## Proposed amendments to ECE/TRANS/WP.29/GRSP/2013/4 (Proposal by Germany of Supplement 6 to the 07 series of amendments to Regulation No. 14)

### I. Proposal

Model A  
(see paragraph 4.4. of this Regulation)

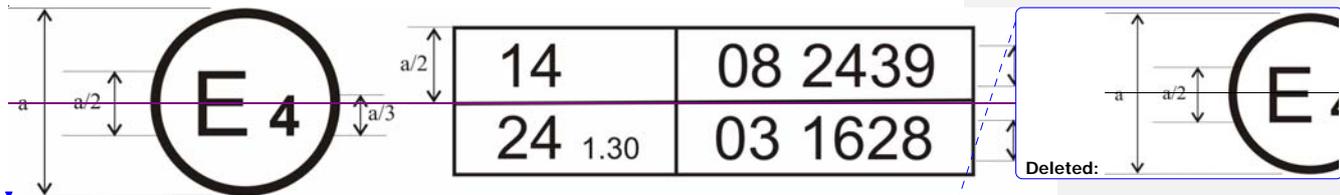
~~The above approval mark affixed to a vehicle shows that the vehicle type concerned has, with regard to safety-belt anchorages, been approved in the Netherlands (E-4), pursuant to Regulation No. 14, under the number 082439. The first two digits of the approval number indicate that Regulation No. 14 already included the 08 series of amendments when the approval was given.~~
